SUNDRY NOTICES AND REPORTS ON WELLS (DO NOT USE THIS FORM FOR PROPOSALS TO DRILL OR TO DEEPEN OR PLUG BACK TO A DIFFERENT RESERVOIR. USE "APPLICATION FOR PERMIT" (FORM C-101) FOR SUCH PROPOSALS.)		WELL API NO. 30-025-40316
1. Type of Well: Oil Well ☒ Gas Well ☐ Other ☐		5. Indicate Type of Lease STATE ☒ FEE ☐
2. Name of Operator BTA Oil Producers, LLC		6. State Oil & Gas Lease No.
3. Address of Operator 104 South Pecos Midland, TX 79701		7. Lease Name or Unit Agreement Name GEM, 8705 JV-P
4. Well Location Unit Letter <u>H</u> : <u>1980</u> feet from the <u>North</u> line and <u>660</u> feet from the <u>East</u> Line Section <u>2</u> Township <u>20S</u> Range <u>33E</u> NMPM Lea County		8. Well Number <u>11H</u>
11. Elevation (Show whether DR, RKB, RT, GR, etc.) 3588' GL		9. OGRID Number 260297
		10. Pool name or Wildcat Teas, Bone Spring

Proposed plan to P&A the subject well as follows:

Conditions of Approval
BTA Oil Producers, LLC
Gem 8705 JV-P # 11H
SHL: Unit H Sec 2, T20S, R33E
BHL: Unit E Sec 2, T20S, R33E
Lea County, NM

Action 438741

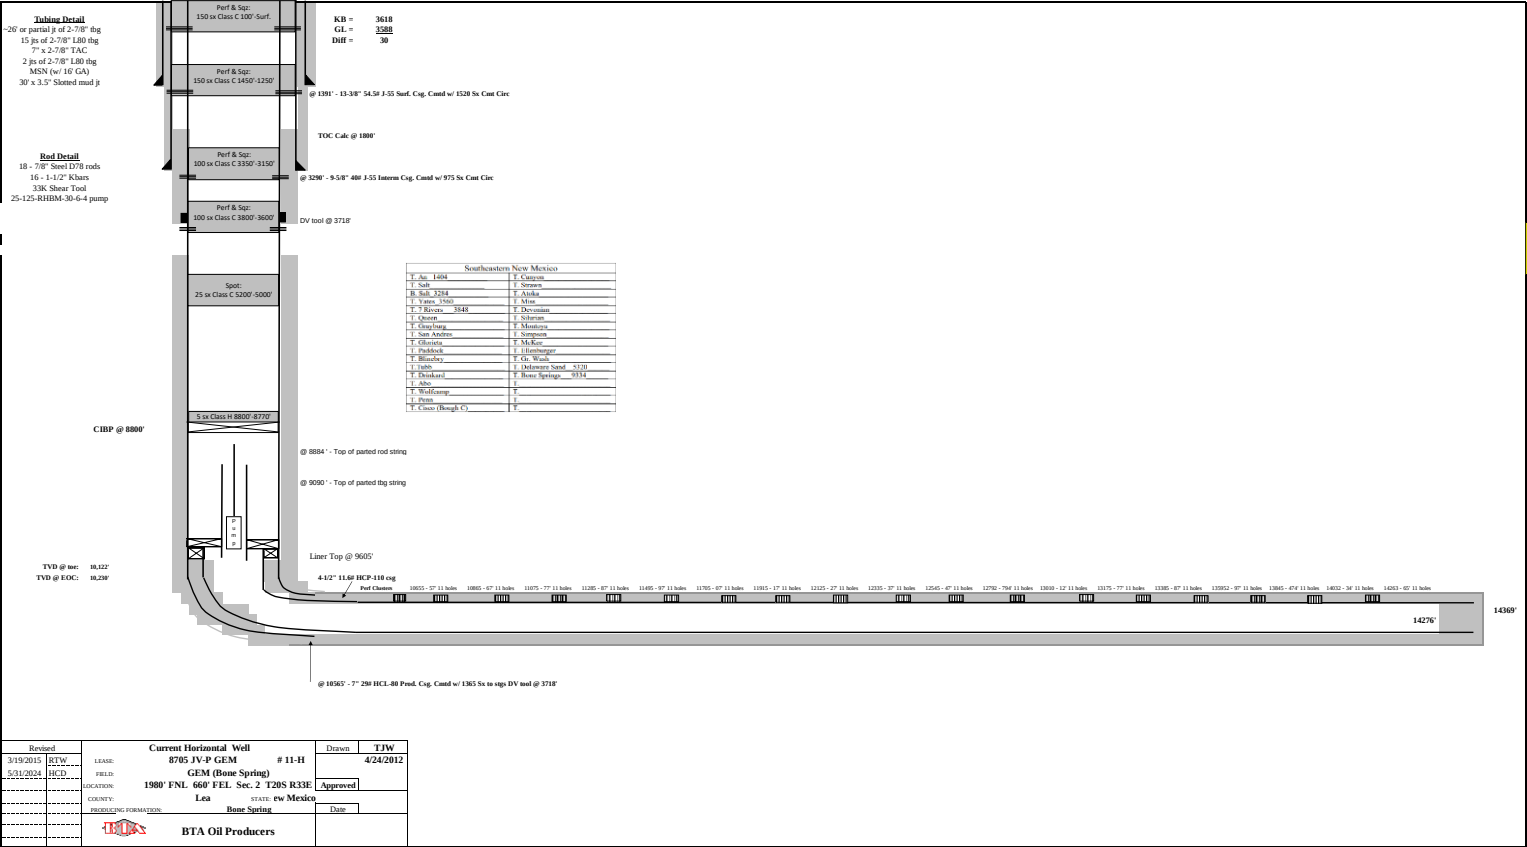
1. Notify NMOCD 24 hours prior to the beginning of plugging operations on this well.
2. Set CIBP @ +/- 8800' over the parted rods and tubing fish. Spot 25 sx Class H cement on top of the CIBP. WOC, tag cement.

3. Load and roll the hole, PT casing, run CBL.
4. Spot an inside balanced plug of Class H cement from 5370' to 5220' to cover the Delaware formation top.

5. Perforate holes at 3768', attempt to establish injectivity into OH x 7" casing annulus below the DV tool. If possible, inject cement through holes under the DV tool and place a cement plug over the DV tool to at least 3668'. WOC and tag cement top.

6. This well is within the R-111Q potash mining area and as such cement must cover ALL casing strings inside and outside from 3340' to 1354'.
 - a. The 7" x 9 5/8" casing annulus TOC from the CBL will determine how to proceed. The 7" x 9 5/8" casing annulus will need to be filled with cement from the TOC to at least 1354'.

- b. Additionally the 7" casing will need to be filled with cement from 3340' to at least 1354'.
7. The 13 3/8" casing shoe will need to be covered from 1441' to at least 1341'. Steps 6 a & b above will determine the best method to use. This may be accomplished with steps 6 a & b.

8. Based on steps 6 a & b above a cement plug is to be placed from 150' to surface.
9. This well is within the LPCH restricted area.
